## 6. Errata

**NEW ACLAND COAL MINE  
STAGE 3 PROJECT**

**Figure 4-7b - Pre revised Project Land  
Suitability – Dryland Cropping  
Mining Area**

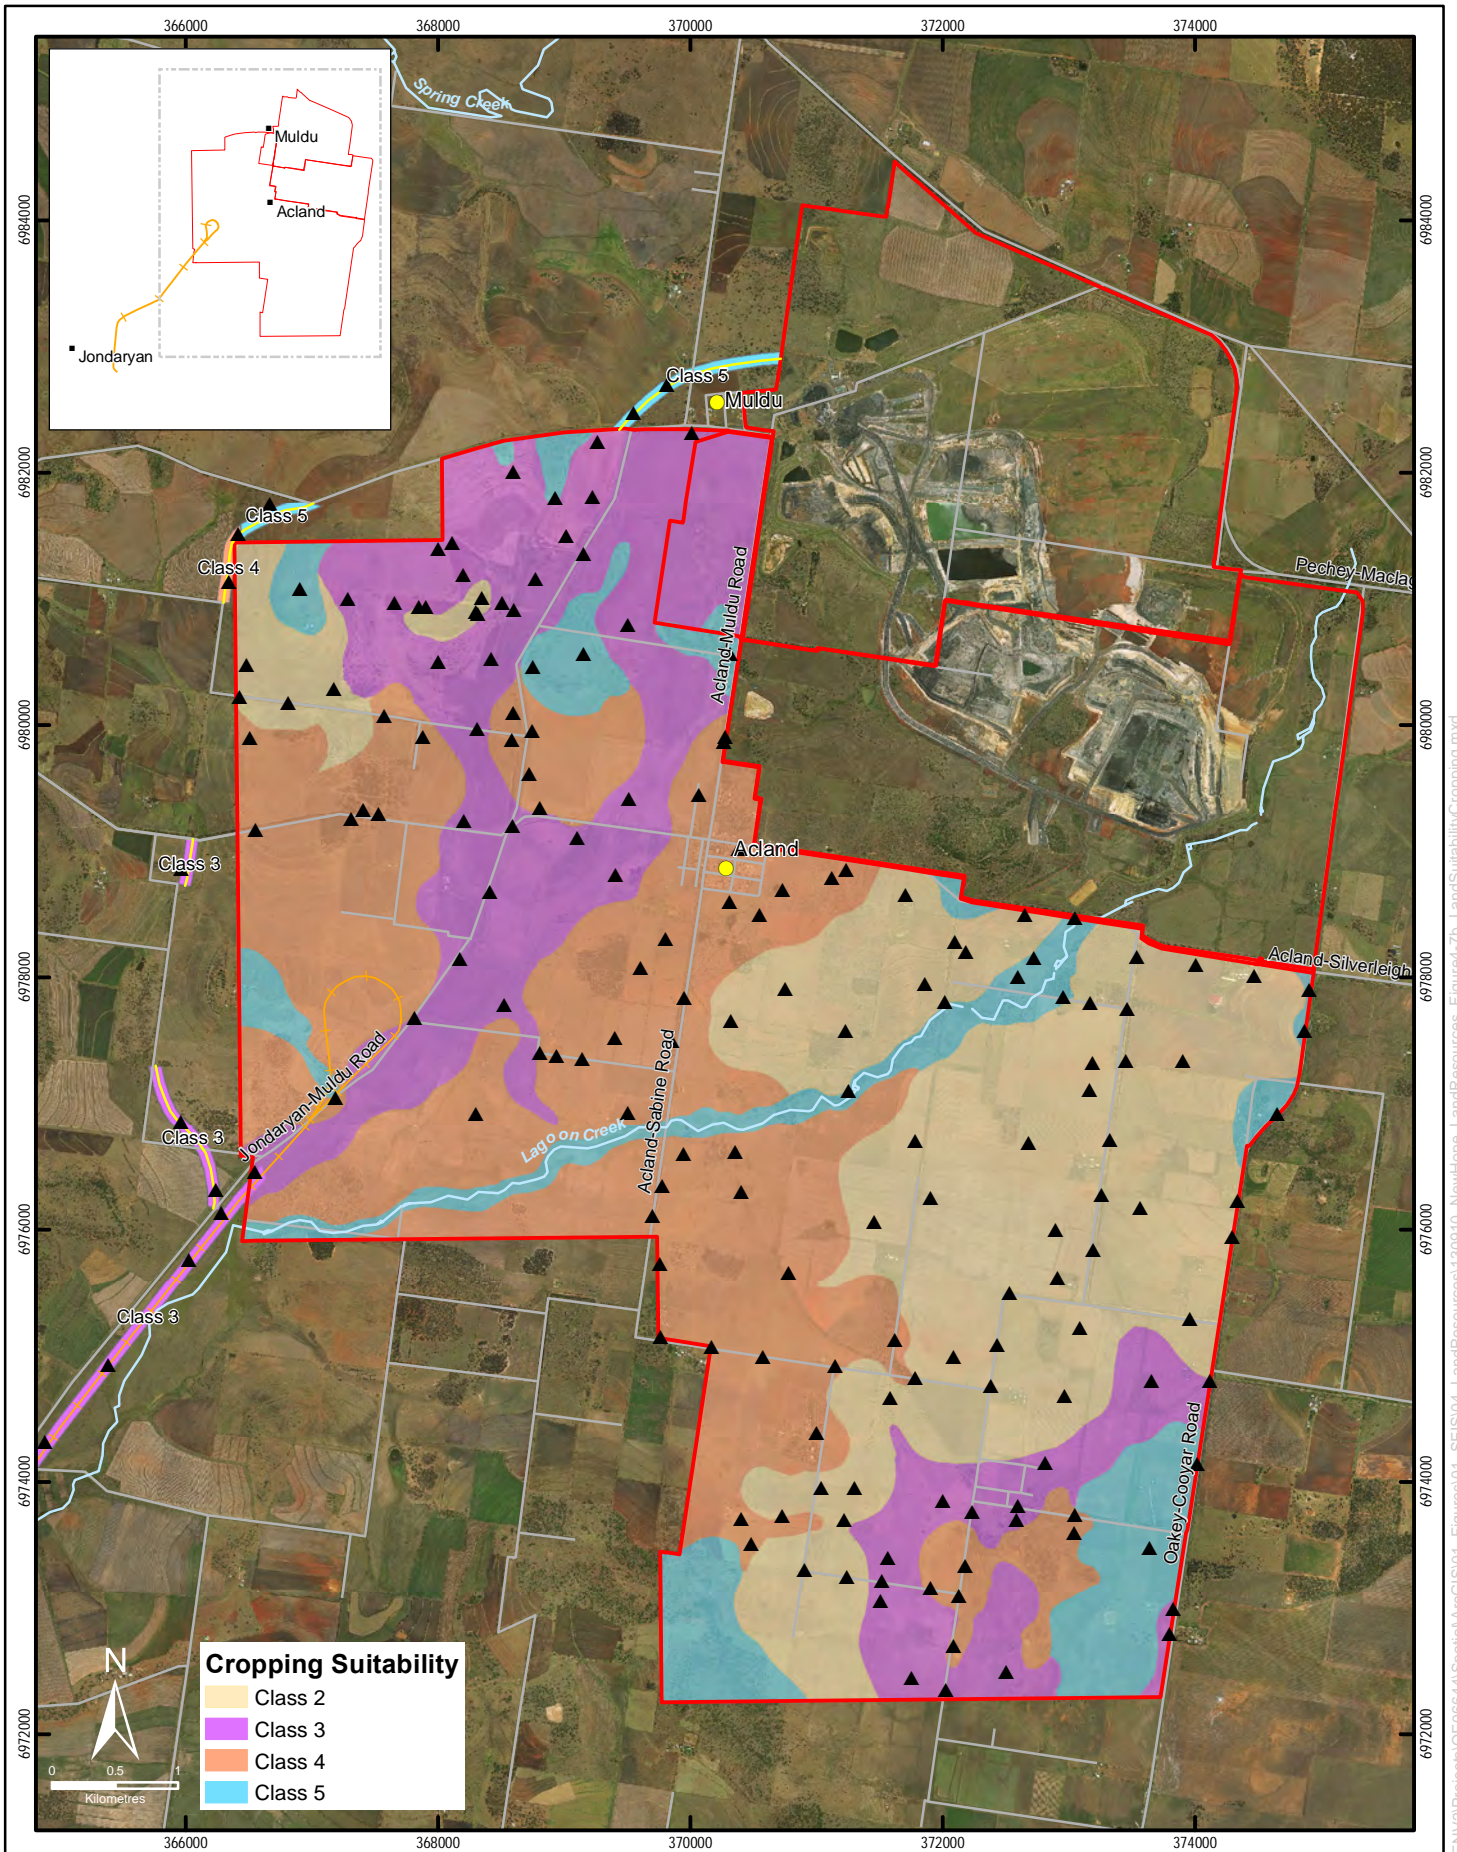
- **Figure 4-7B** of the draft EIS has been updated, and is presented in below.
- The statement in **Section 4.8.3**, page 4-68 of the draft EIS should read:

**Figure 6.4-A Annual Controlled Release Volume**

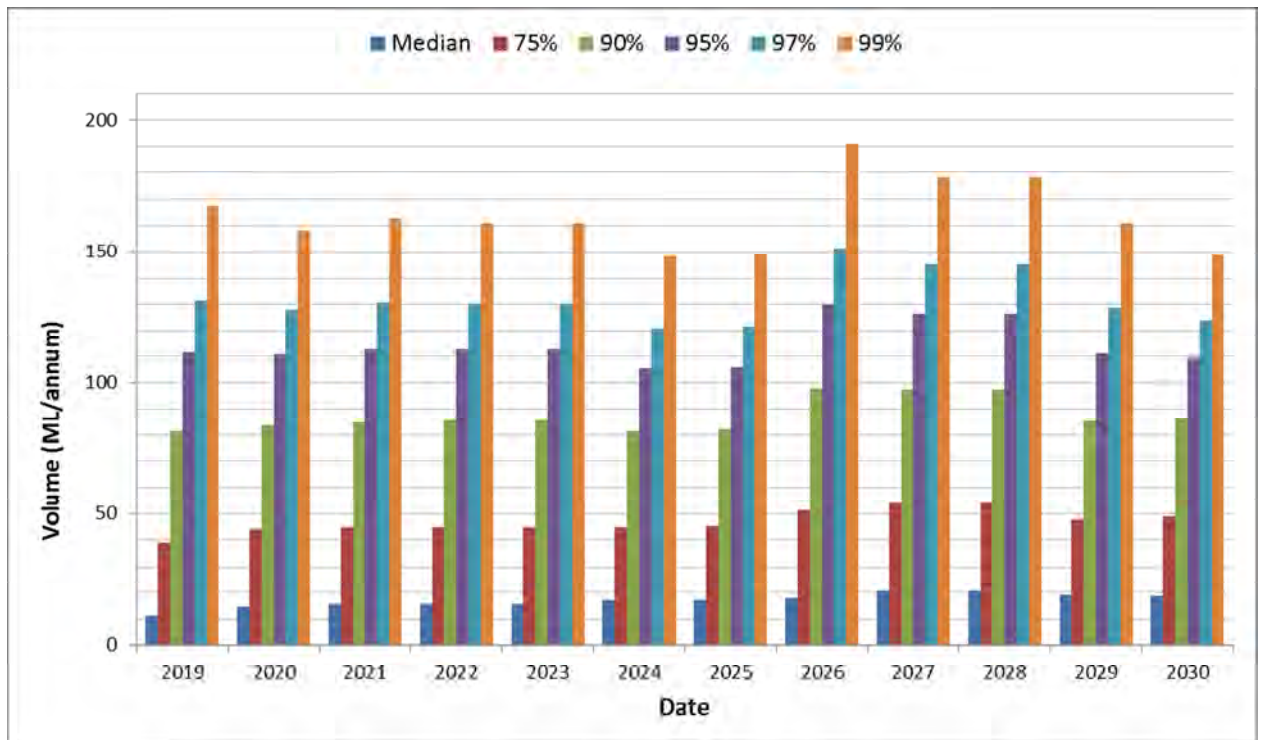
- It is noted that the annual controlled release volume presented in **Figure 5-35** of **Chapter 5** of the draft EIS and **Figure 5-3** of the Water Resource Management Plan (**Appendix J.4** of the draft EIS) presents the total volume predicted to be released over a given year. That is at the 99<sup>th</sup> percentile of the probabilistic rainfall (very wet year) there is predicted to be 190 ML released in the year 2027. An updated chart is provided in **Figure 5.2-S** below.

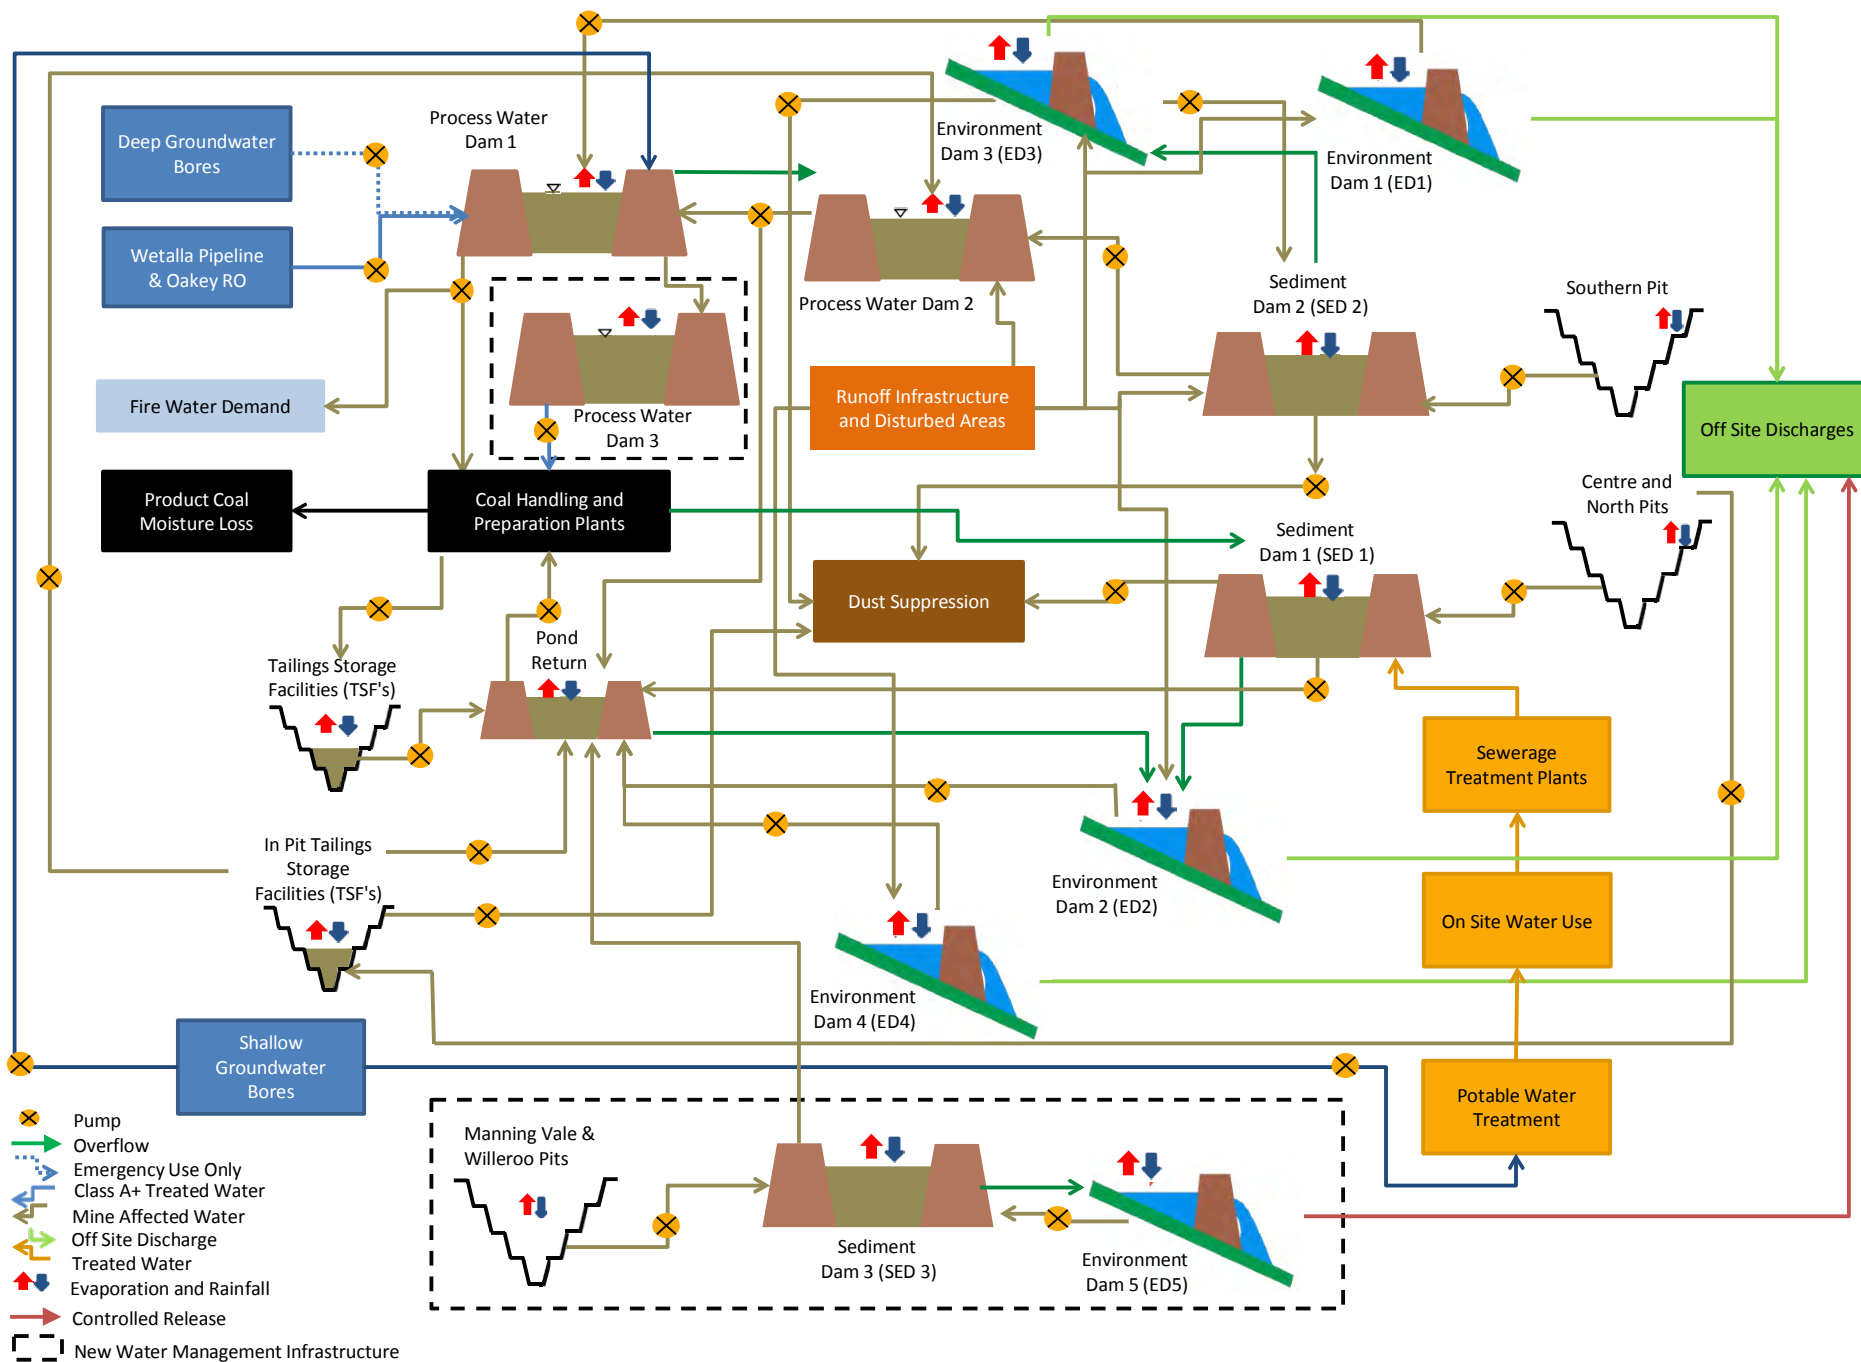
The dark orange arrows in **Figure 5-32** of the draft EIS were displayed in error as these arrows were attached to the base graphic and should have been removed. The updated Schematic is presented below.
